ADDENDUM | UL 3741 Compliance with Tesla MCIs, Powerwall, and Solar Inverter

Published 02-27-2026

The "Always 4" Rule: Always Install (4) MCI-2s on Each String

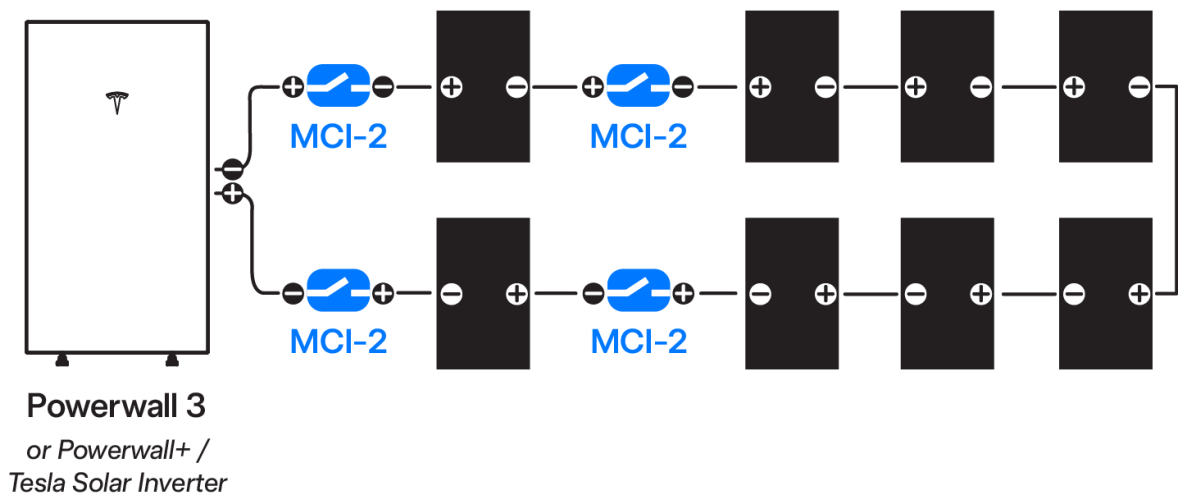
Requirements:

Maximum (2) arrays per string*

- At least (1) MCI must be placed on each end of the string
- MCI-2s are not allowed to be plugged directly into each other due to risk of damaging the connectors from rotating them.

- String spans 1 array: Install a total of (4) MCIs, (1) MCI on each end of the string. The other two can be placed anywhere in the string but it is suggested to locate them near the ends as well

Using MCI-2 for 165V & 600V PVHCS Applications, cont.

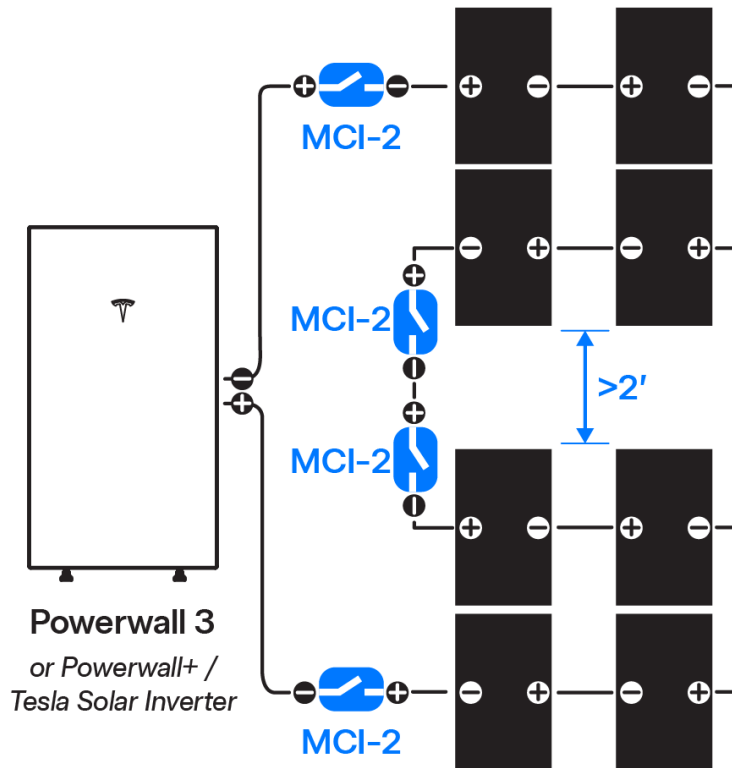
- String spans 2 arrays: Install (1) MCI on each end of the string, and (1) MCI on each end of the jumper (for a total of (4) MCIs)

*Rule created for simplicity. Designs should either prohibit 3 arrays per string or use Tesla's 165V inside-the-array PVHCS listing.
